Hi-Fi Products
Service Bulletin

Model: TA-AV480

No. 128

Subject: AC Line/Click Noise

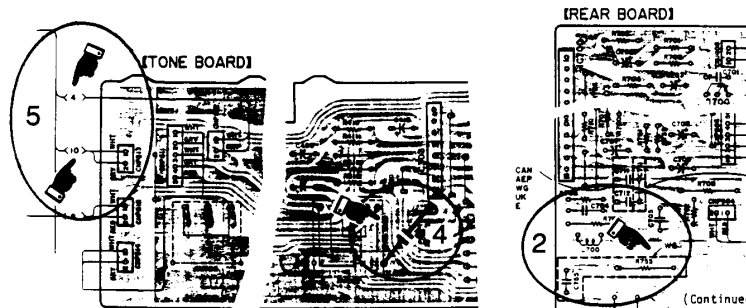
Symptom:
(54)

There is a click noise in the speaker output when switching other devices on the same AC line On or Off.

- Solution:**
1. Check whether the tone board contains the capacitors C317 and C417. If it does not, install them.
 2. Add the following components, including the groundings with the chassis.

Board	Component
Main	C510A, C610A, C122, C123
Rear	C755, R755

3. Add four 0.022uF capacitors (P/N 1-161-494-00) on the main board.
4. Add a 0.022uF capacitor (P/N 1-161-494-00) on the tone board.
5. Replace cables 4 and 10 between the tone board (output) and the main board (power amp input) by shielded wires, and connect the shielding also to the ground of the tone board. The part number for a 38 ft. roll of two conductor shielded wire is 9-919-538-00.
